Item Name: Crosstube Turning Detail

DART AEROSPACE LTD	Work Order:	107776
Description: Crosstube Assembly	Part Number:	D407-667-145
Inspection Dwg: D407-667-145 Rev: C		Page 1 of 2

DRAWING NO. D407-667-145	TITLE CROSSTUBE ASS'Y (407 HIGH FWD)	REV. C	DART AEROSPACE LTD ENGINEERING ORDER		D.E.O. NO. D407-667-145-C-1	SHEET NO. SHEET 1 OF 1	SCALE NTS
DRAWN <i>Q</i>	CHECKED <i>ASS</i>	MFG. APPR. <i>AB</i>	APPROVED <i>WD</i>	DE APPR. <i>HA</i>			
DATE 11.07.15	DATE 11.07.22	DATE 11.07.22	DATE 11/07/22	DATE 11.07.21

DRAWING NO. D407-667-145	TITLE CROSSTUBE ASS'Y (407 HIGH FWD)	REV. C	DART AEROSPACE LTD ENGINEERING ORDER	D.E.O. NO. D407-667-145-C-2	SHEET NO. SHEET 1 OF 1	SCALE NTS
DRAWN AJS	CHECKED	MFG. APPR. E	APPROVED 140	DE APPR.		
DATE 12.08.02	DATE 12.08.02	DATE 12.08.02	DATE 12.08.02	DATE 12.08.02	DATE 12.08.02

DETAIL P
BONDING STRAP INSTALLATION 2 PL

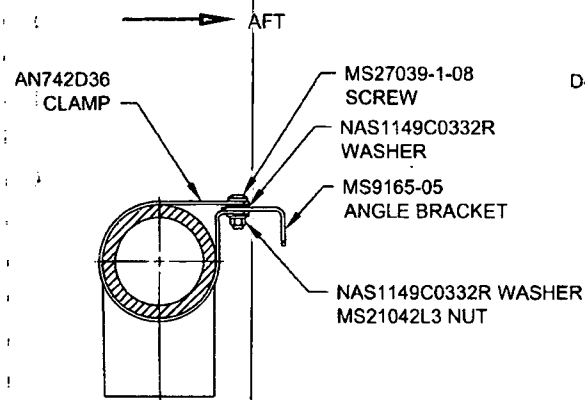
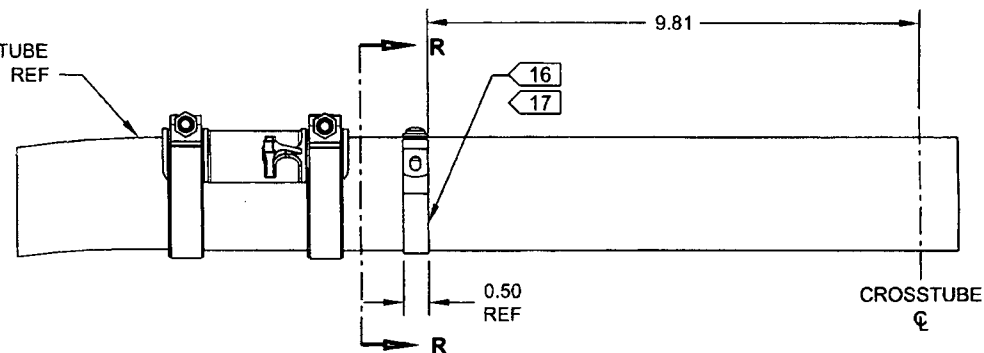
ADD ELECTRICAL GROUNDING STRAP

ITEM	QTY -145	PART NUMBER	DESCRIPTION
1	X	D407-667-145	CROSSTUBE ASSEMBLY (407 HIGH FWD)
10	2	AN742D36	CLAMP
11	2	MS9165-05	ANGLE BRACKET
12	2	MS21042L3	NUT (OR MS21042-3)
13	2	MS27039-1-08	SCREW
14	4	NAS1149C0332R	WASHER (OR AN960C10L)

- 16) MASK AREA UNDER CLAMP PRIOR TO PAINTING
- 17) SEAL EDGES WHERE AN742D36 CLAMP MEETS WITH THE CROSSTUBE USING SIKAFLEX-241/-291 OR MIL-S-8802 CLASS B2 OR PROSEAL 890 SEALANT
- 18) PERFORM RESISTANCE CHECK TO ENSURE MAX RESISTANCE IS 10 MILLIOHMS
